**Louth County Council
Planning Report**

Planning Ref: 25/60656
Applicant's Name: Ballygorman Contracts Ltd.
Date of site inspection: 04/11/2025
Site Notice: Yes (notices in place.)
Type of Application: Permission & Retention Permission
Description: Permission & Retention Permission:

Site Location: Ardee Street, Collon, Co. Louth
Submissions: 19/11/2025
Report Date: 25/11/2025
File Due Date: 10/12/2025

Fig 9: Proposed Site Plan

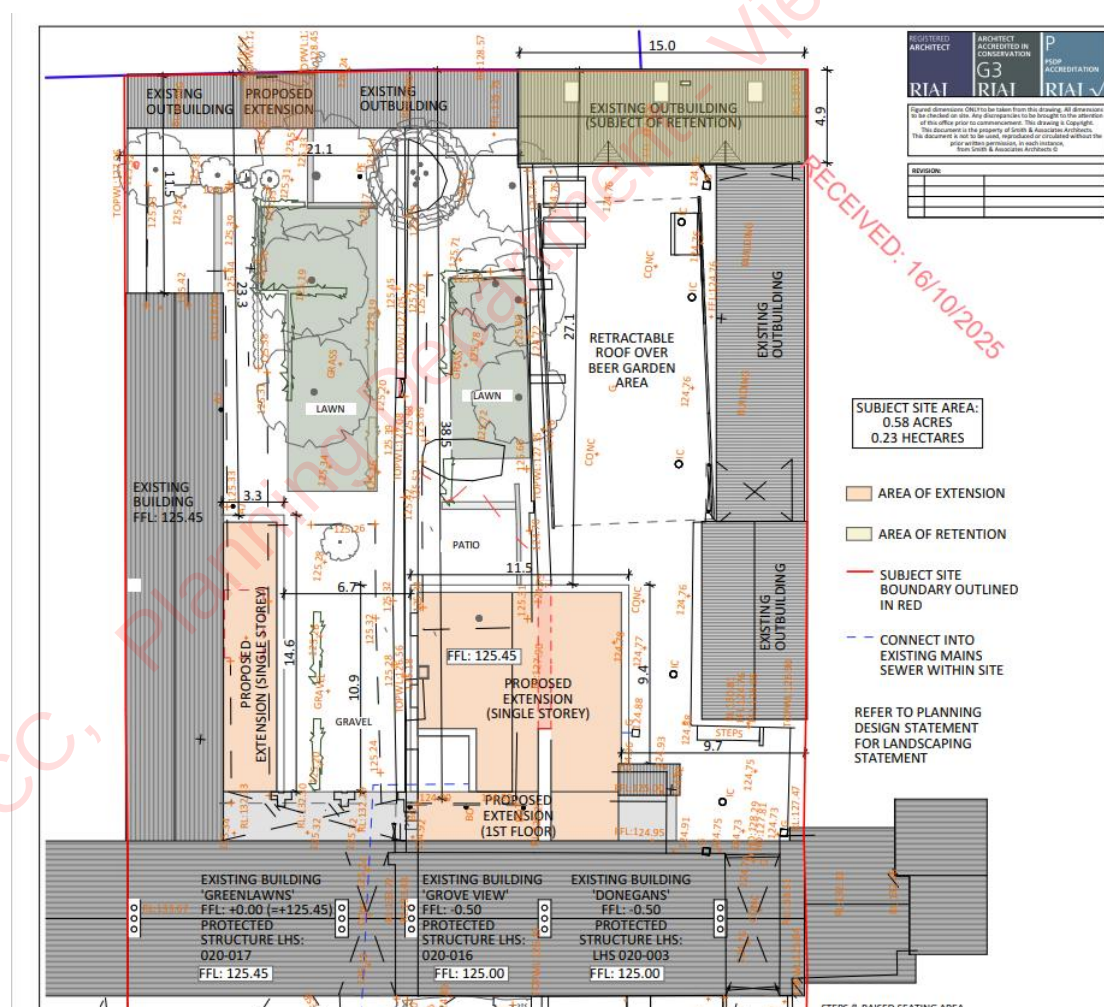
The submitted Planning Statement (Section 5.0) indicates a requirement of 17 spaces, however I note that this does not appear to include the proposed beer garden and as such, this calculation is lower than the required figures of 32 no. parking spaces as outlined above, in relation to the proposed development. This does not include the existing parking arrangements associated with the established bar on the site.

- b) The proposal includes a change of use of the existing yard within Donegan's to a beer garden. The drawings also indicate an associated kitchen and bar, however it is unclear whether the intention is to serve food in this outdoor area. This should be clarified and the proposed change of use be included within the proposal description in the interest of accuracy and transparency. The applicant is also requested to clarify the nature of activities within this area and the associated hours of operation.

The Planning Authority has concerns in relation to the potential impacts of the development on the amenities of surrounding residents, particularly in relation to the proposed beer garden and reception / events room and the associated activities, including noise.

- a) An updated parking calculation for the proposed development, including the proposed beer garden.
 - b) To submit a feasible parking solution for the proposed development, in accordance with Section 13.11. of the Louth County Development Plan 2021-2027, as varied. This shall include a formal authorised arrangement/s for the use of third-party lands, where applicable.
 - c) The applicant in addressing the above, shall include an alternative solution in the event that the existing carpark is not feasible and where for example lands relied on are developed in the future or become no longer available.
- 6.** The applicant is requested to submit confirmation of feasibility from Uisce Éireann that the intended connections to the Irish Water Network for both water supply and wastewater can be facilitated for the proposed development at this time.

Fig 10. Proposed Front Streetscape (western) Elevation

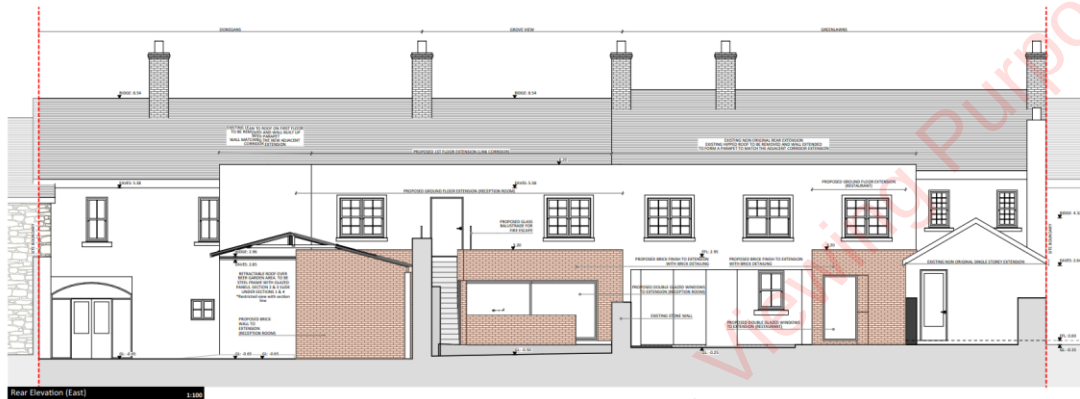
In having regard to the objectives of the ACA outlined above and Policy BHC 31, the submitted details are arguably limited in relation to the following:

- Justification for the replacement of existing windows which are important features within the ACA and Protected Structures, including for example a condition survey report.
- The methodology for the proposed replacement of existing windows.
- Details of which windows are proposed to be replaced.
- Detailed specification of external finishes for all external elements of the front façade and forecourt of the building.
- Details for the associated signage for the guesthouse.
- Details in relation to the referenced updating of steel frame signage at Donegan's, or indeed the alterations / repairs to the front, shopfront.
- Details of the proposed decorative railing to the front of Donegan's.
- Details of the proposed steps and raised seating area to the front of Donegan's.

- c) A detailed schedule of external finishes on elevation drawings, for all elements of the proposal.
- d) The applicant is requested to clarify which windows are proposing to be replaced within the front elevation and shall detail why their replacement is necessary, in lieu of restoration and / or repair.

- e) Details of all associated signage and shopfront detailing, in accordance with the above guidelines.
- f) Detailed drawings to clearly detail all elements of demolition.
